Re: State of Oregon Hydroelectric Application Review Team Comments on
PacifiCorp's Draft License Application for the Klamath Hydroelectric
Project Relicensing (FERC Project 2082)

**COMMENTS ON PACIFICORP'S
DRAFT LICENSE APPLICATION**

**The Klamath Hydroelectric Project
(FERC P-2082)**

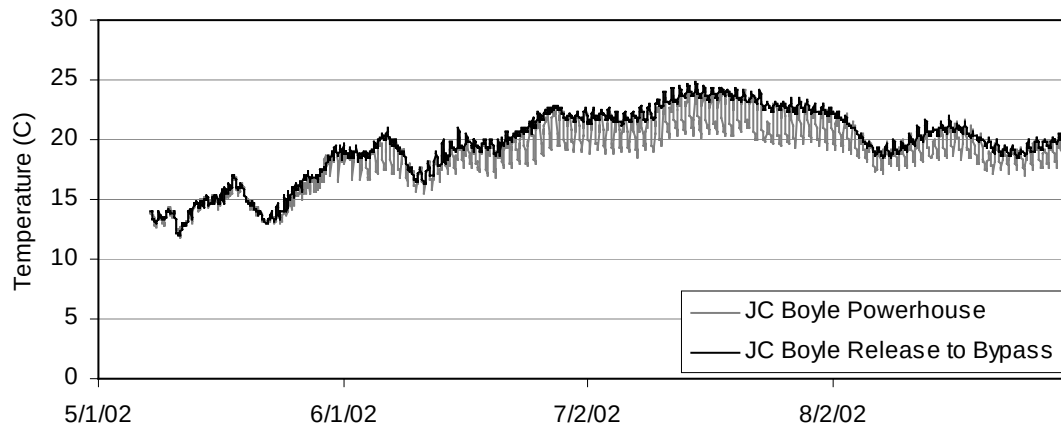
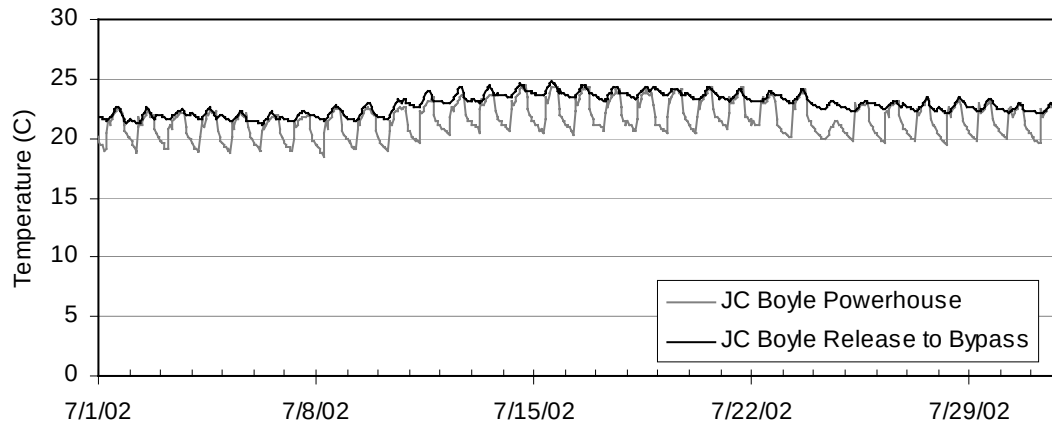
4.7.1.1 p 4.10: Junctions are required in the model to create a branching network. As seen in Figure 4.7-2, the powerhouse returns are represented as small "branches" (one element in length and each element has three nodes) flowing into Link River. Where the branches join Link River in the model, a special "junction" element is necessary. Junctions are used because the flows entering the Link River from East and West Side Powerhouses can make up an appreciable portion of the flow in the river and junctions assist in properly accounting for conservation of mass and momentum to simulate flow and water surface. The two additional elements and the special junction element result in an additional eight nodes in the
